IWG-DPPS

Defining Head Test Area

5th Meeting (2019.09.03~04)

Seung Hoon LEE (Senior Researcher)
Kore Automobile Testing & Research Institute, Korea Transportation Safety Authority

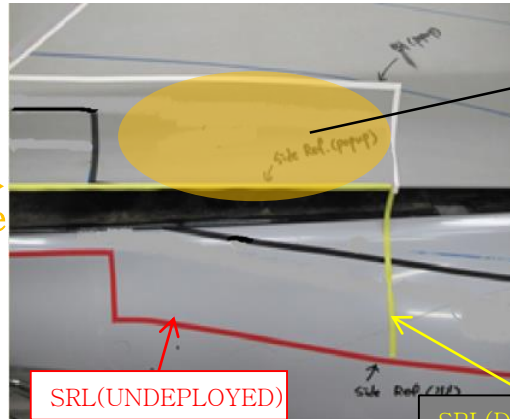
This may allow manufacturers to intentionally reduce the test area using DPPS

Enlarge

Defining the test area in the un-deployed position → The test area is consistent at all times

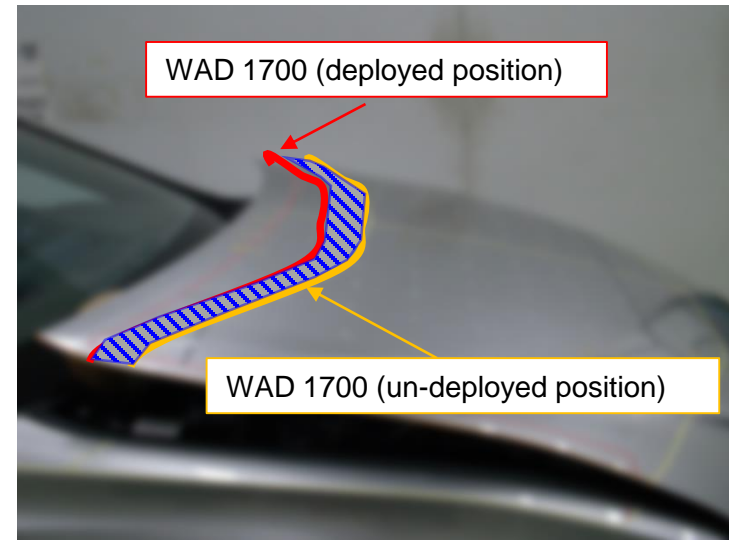
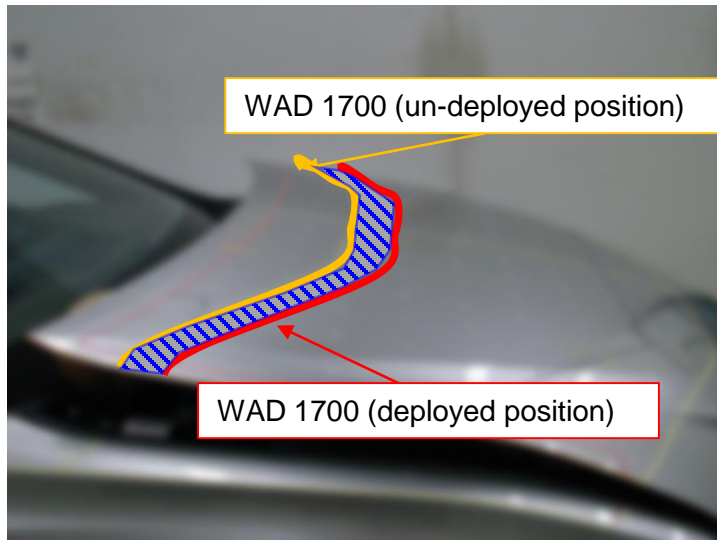
Deployed position → Untestable
Un-deployed position → Testable

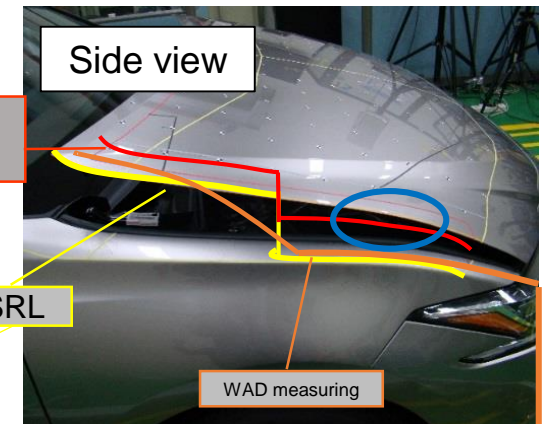
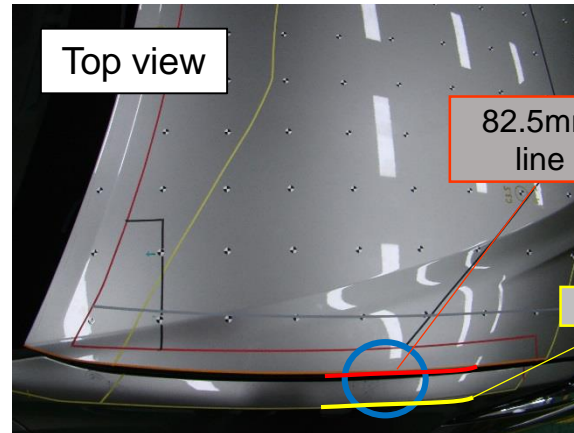
○ Void space between deployed hood and body

- When the deployable hood is lifted, it may not be possible to mark reference lines or others
 - rear reference line / side reference line
 - WAD line

→ **We may need lots of new definitions to clarify these kinds of unpredicted cases !
if OICA proposal is applied**

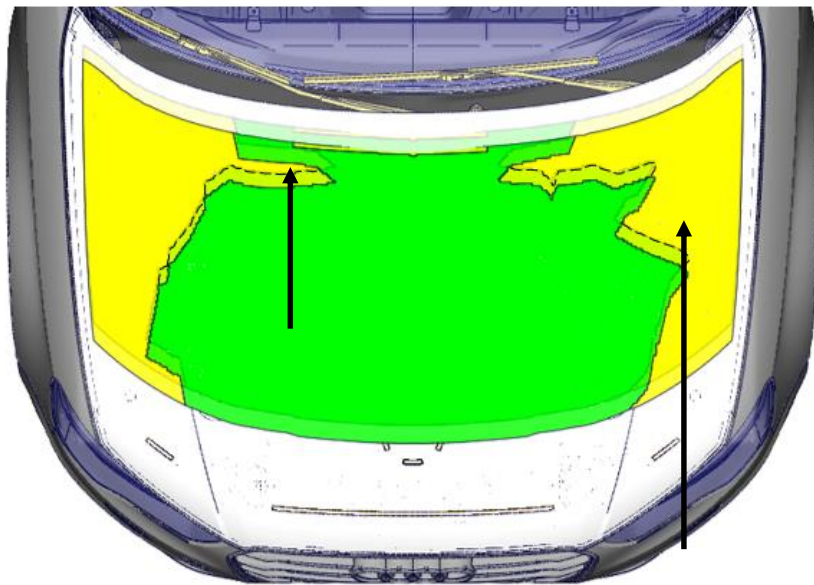
- Deployable bonnet is moving in x-direction
- A correct determination and marking of HIC1000 zone and HIC1700 zone (2/3, 1/3) is not possible if marking is done in undeployed position

Requirement	
■	Zone HIC 1000: 67.66%
■	Zone HIC 1700: 32.34 %

HIC 1000/1700 zone is derived from the headform test result conducted at impact points, whether the test area is defined at the deployed position or at the un-deployed position
